NUMBER: 21-037-15 REV. A

GROUP: Transmission and Transfer Case

DATE: July 24, 2015

Transmission Heater Assembly Reinforcement Plate

Fig. 1 Transmission Heater Assembly

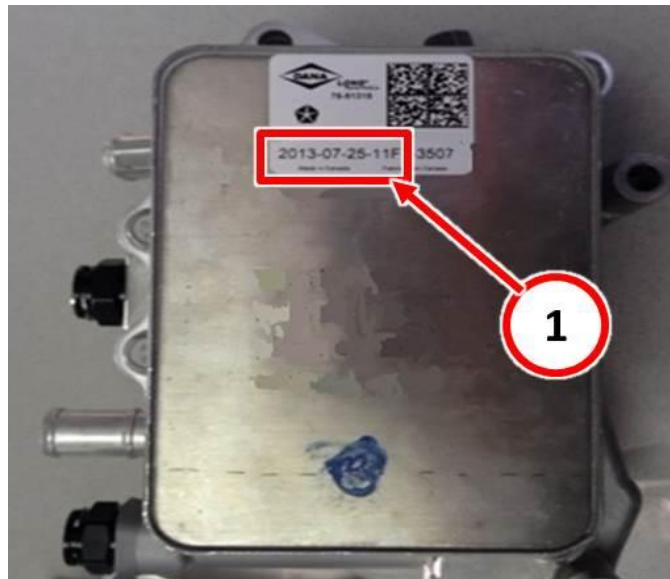
1. Raise and support the vehicle on a suitable hoist. Refer to detailed service procedures in DealerCONNECT/TechCONNECT Service Info Section 04 - Vehicle Quick Reference> Hoisting> Standard Procedure.
2. Visually inspect the side casing of the Transmission Heater Assembly to determine the build date.

-
3. Is the build date on the Transmission Heater Assembly between 2014-12-02 and 2014-12-09?
 - a. Yes >>> Proceed to [Step #4](#).
 - b. No >>> This service bulletin does not apply. Further diagnosis is required including pressure testing of the Transmission Heater Assemblies outside of the build date range above.
 4. Replace the Transmission Heater Assembly. Refer to detailed repair procedures in DealerCONNECT/TechCONNECT Service Info Section 21 - Transmission and Transfer Case> Automatic - 8HP70/845RE> HEATER, Transmission> Removal/Installation.
